Product Change Notice (PCN)

PCN Number: PCN-0374670R-01

Product(s) Affected: CS-8406 & CS-8412

Top	Side	Bottom
CS-84XX OLD			
CS-84XX NEW

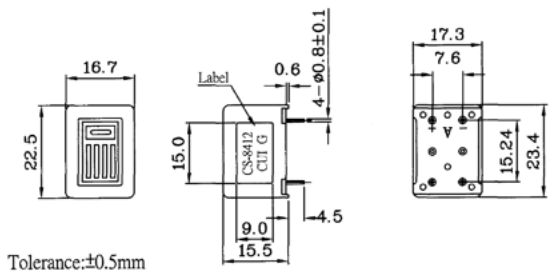
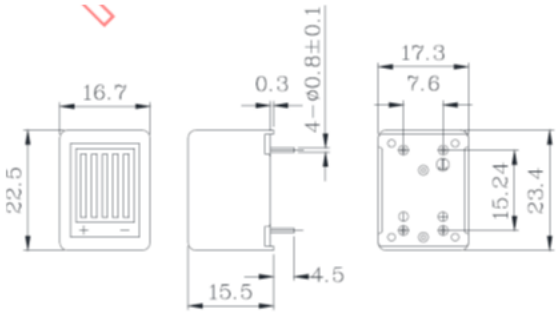
Description of Change: *No functional changes have occurred, the case color will be black moving forward and the sound holes have been elongated with some minor dimensional changes (see photos below).*
